SERVICE BULLETIN NO: 1005

FUSELAGE - GENERAL CONTROL COLUMN SUPPORT ON FRAME 2 - INSPECTION

PILATUS B4-PC 11

Support Frame 2 - Inspection
Figure 1

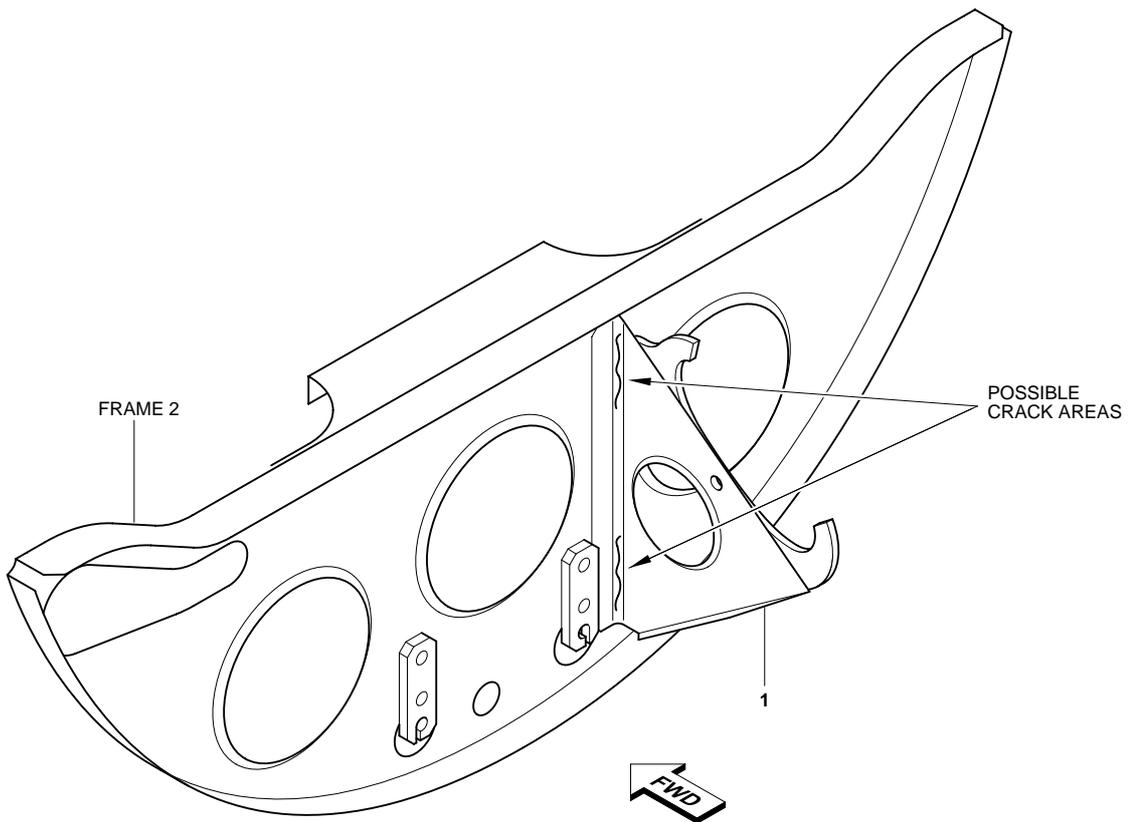
Cracks can occur in the support to which the control-column is attached.

- (1) Use a source of bright light and X10 magnifier and examine support (1) for cracks. Do this specially in the areas of the upper and lower bend angles where the support (1) is attached to Frame 2.
- (2) Cracks are not permitted in the support (1). Replace the support (1) if you find cracks.
- (3) Do the inspection again at each annual servicing.

Examine the support and replace it if cracked.
